TX/RX_num_unit_change Signals

Richard Tse, Microchip Technology
David Law, Hewlett Packard Enterprise

IEEE 802.3cx Plenary, July 21, 2021

Figure 90-1—Relationship of the TimeSync Client, TSSI and gRS sublayer relative to MAC and MAC Client and associated interfaces

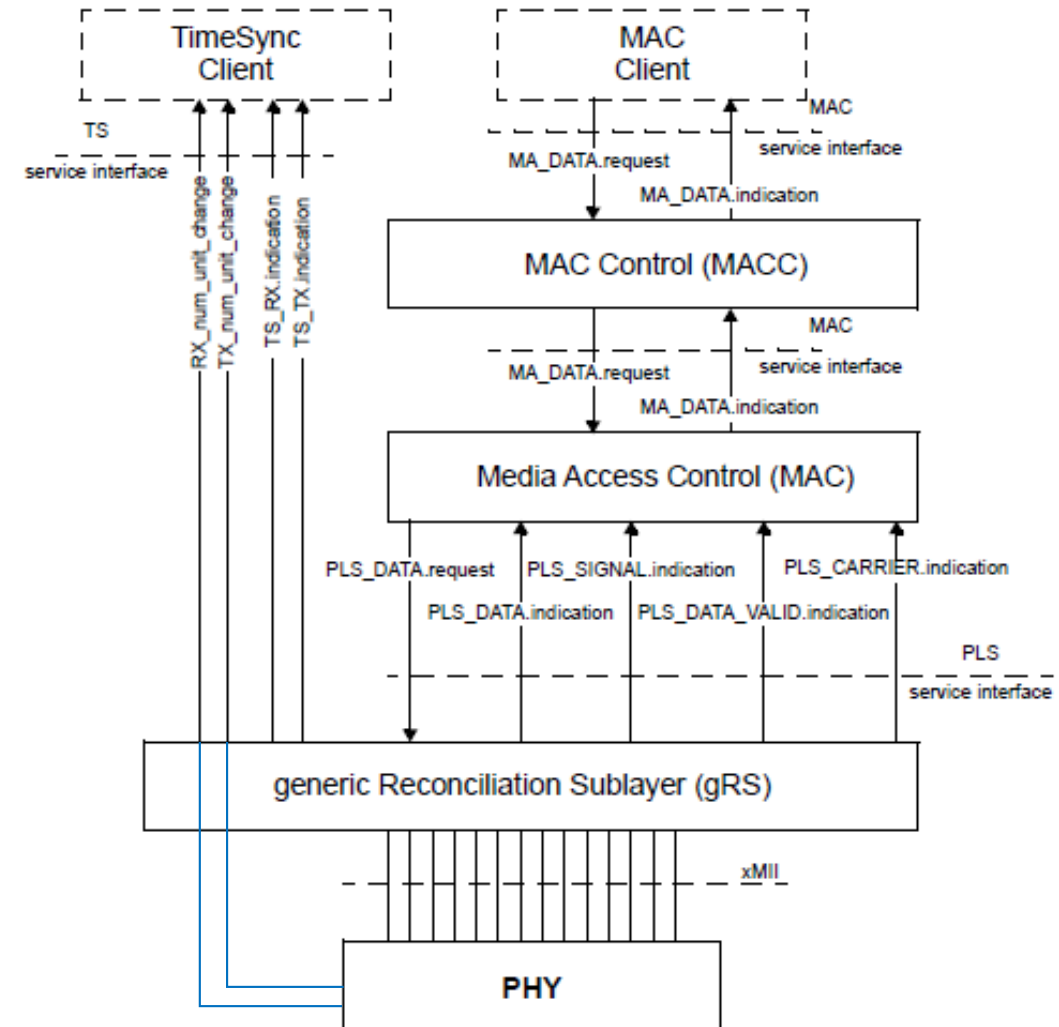
- TX/RX_num_unit_change signals are generated by the Tx/Rx PHY
 - TX/RX_num_unit_change_support register is already located alongside other PCS registers
- TX/RX_num_unit_change signals are aligned to TXD/RXD signals on the xMII
- The new lines (in blue) connecting the PHY to the gRS and TimeSync Client are shown in the updated Figure 90-1 and Figure 90-2

- Update **Figure 90-1** and **Figure 90-2** as shown earlier in this presentation
- Rename **Figure 90-2** to **Figure 90-4** (two new figures are to be inserted)
- Change **90.4.2 TSSI** as follows:

Figure 90-2—TS_MTP_Detect_TX and TS_MTP_Detect_RX functions within the generic Reconciliation Sublayer (gRS)

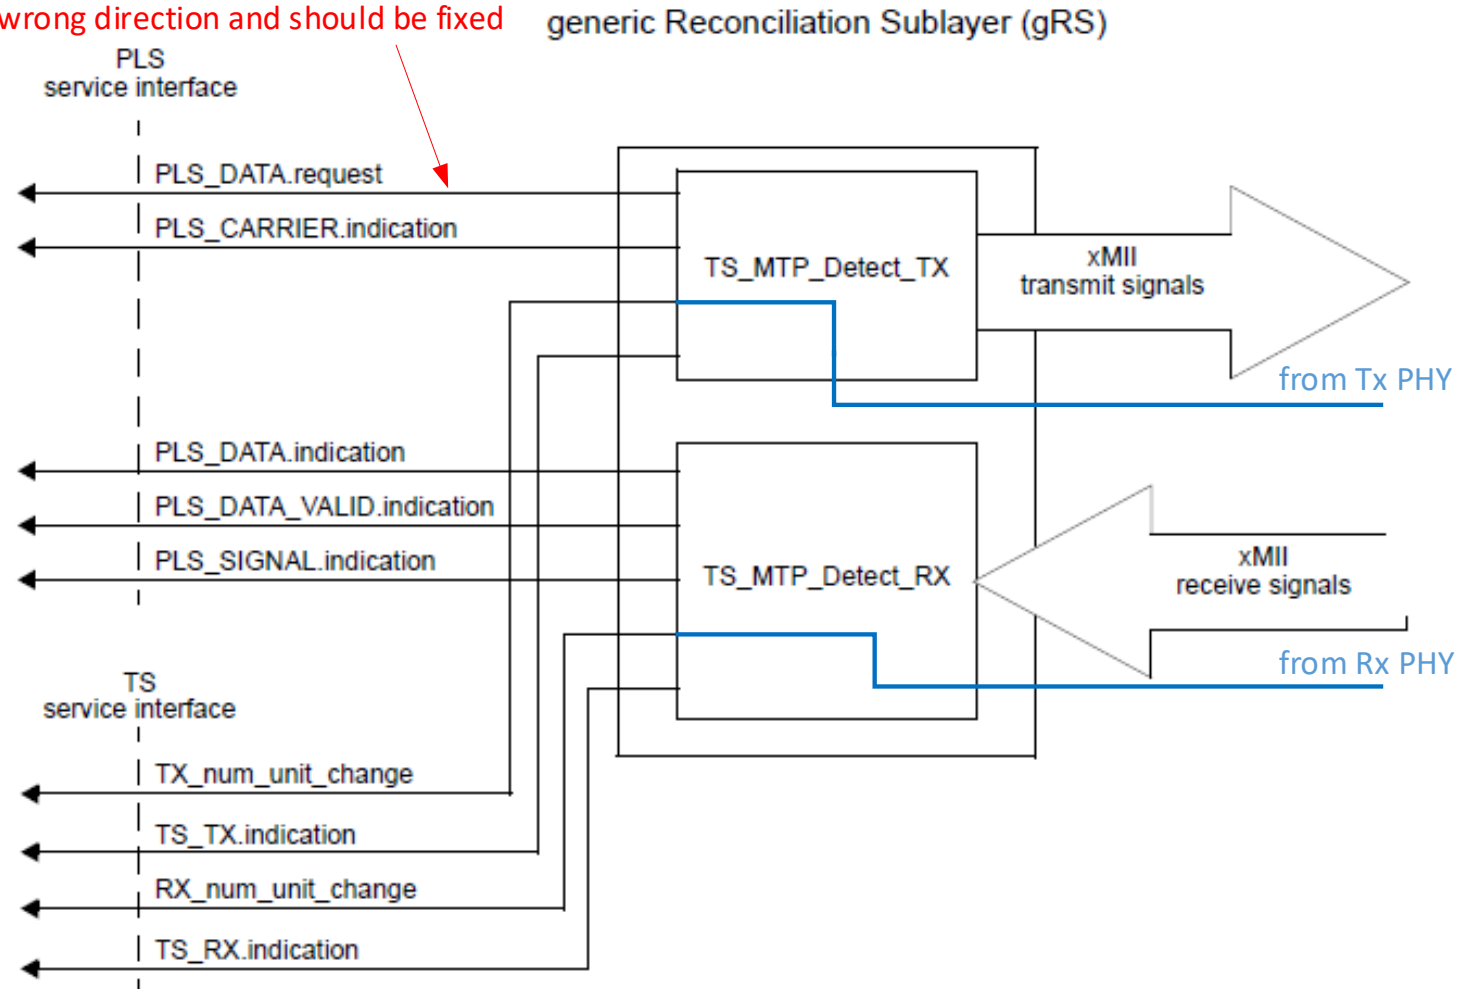
Also note that this arrow is pointing in the wrong direction and should be fixed

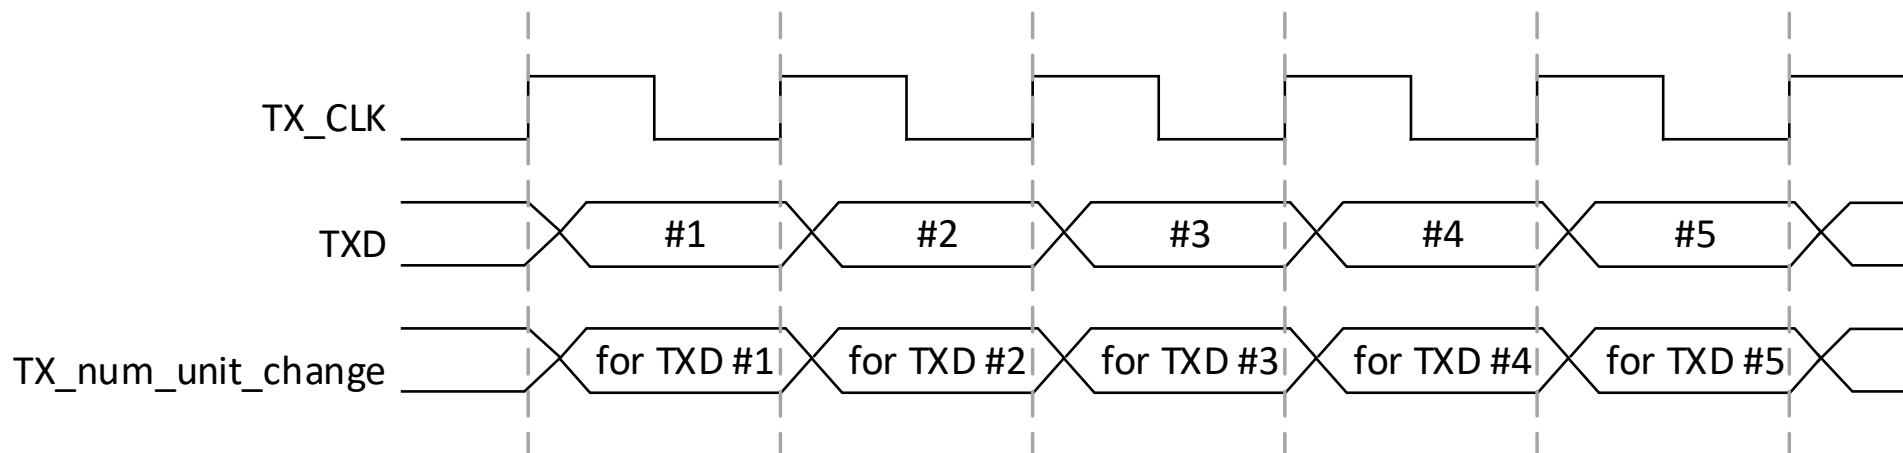
TX_num_unit_change gives advanced notification of Tx PHY path data delay changes (from upcoming AM, CWM, and Idle insertion/removal) for the TXD on the xMII

- Since AM, CWM, and Idle insertion/removal are controlled by the PHY, the PHY can generate advanced notification of these events
- TX_num_unit_change is updated by the Tx PHY on the active edge of TX_CLK before TXD is sampled by the Tx PHY

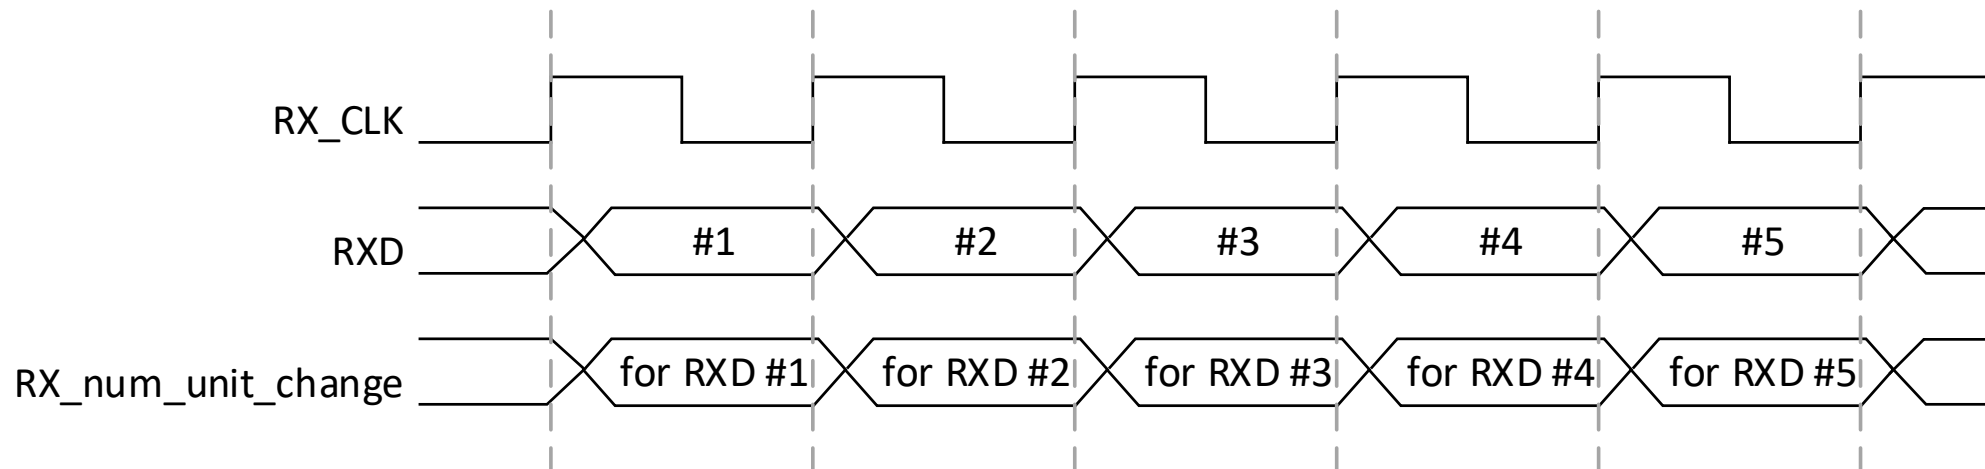
RX_num_unit_change gives the change in Rx PHY path data delay (due to AM, CWM, and Idle insertion/removal) experienced by the RXD on the xMII

- RX_num_unit_change accompanies each valid RXD on the xMII
- RX_num_unit_change is updated by the Rx PHY on the active edge of RX_CLK in the manner as RXD

Figure 90-2 — Relationship between TXD and Tx_num_unit_change

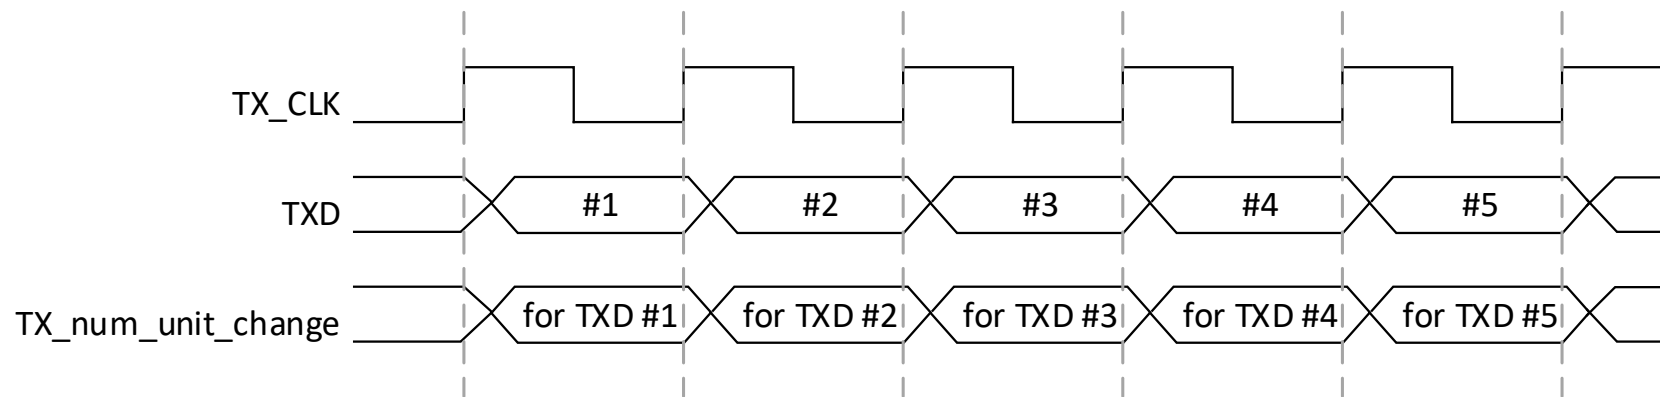
Tx_num_unit_change is generated by the Tx PHY for every Tx xMII word that it receives.

Tx_num_unit_change indicates the change in the Tx PHY's path data delay due to AM insertion, CWM insertion, and/or Idle rate adaptation insertion/removal for the corresponding Tx xMII word. If a Tx PHY does not perform these changes to its path data delay, then this primitive signal is fixed to the value zero.

Figure 90-3 — Relationship between RXD and Rx_num_unit_change

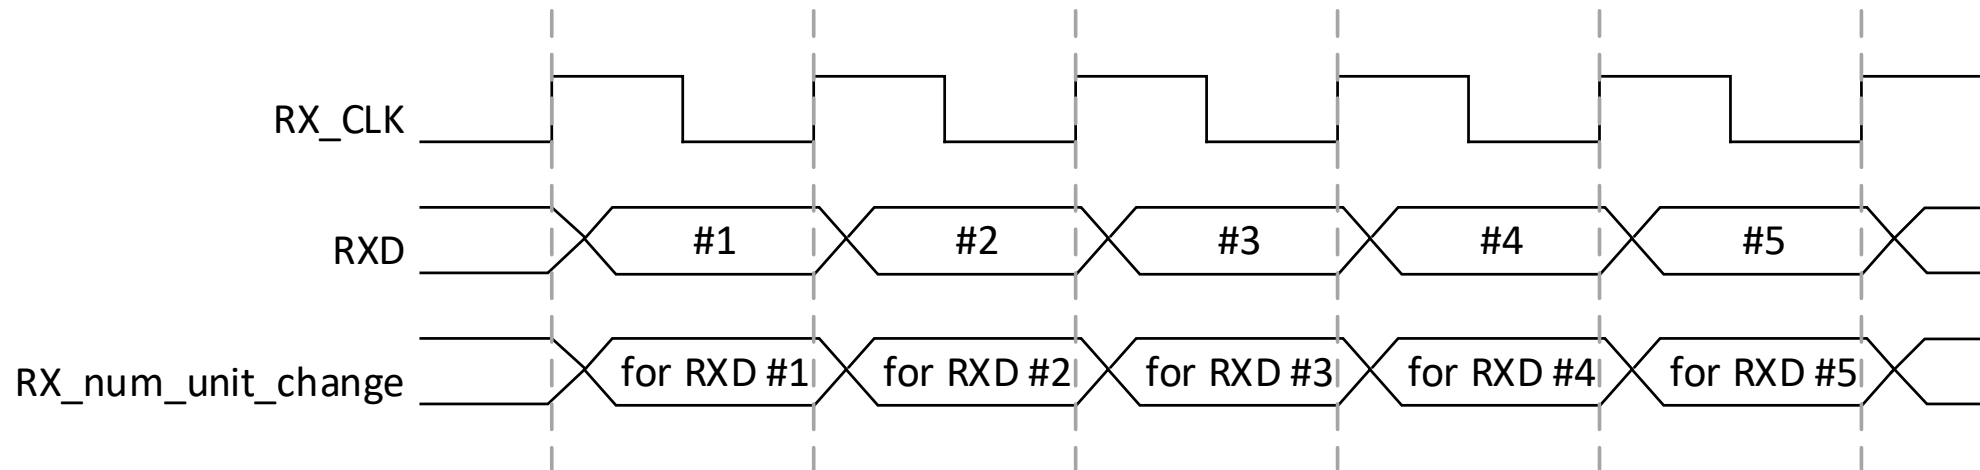
Rx_num_unit_change is generated by the Rx PHY for every Rx xMII word. Rx_num_unit_change indicates the change in the Rx PHY's path data delay due to AM removal, CWM removal, and/or Idle rate adaptation insertion/removal for the corresponding Rx xMII word. If a Rx PHY does not perform these changes to its path data delay, then this ~~primitive~~signal is fixed to the value zero.
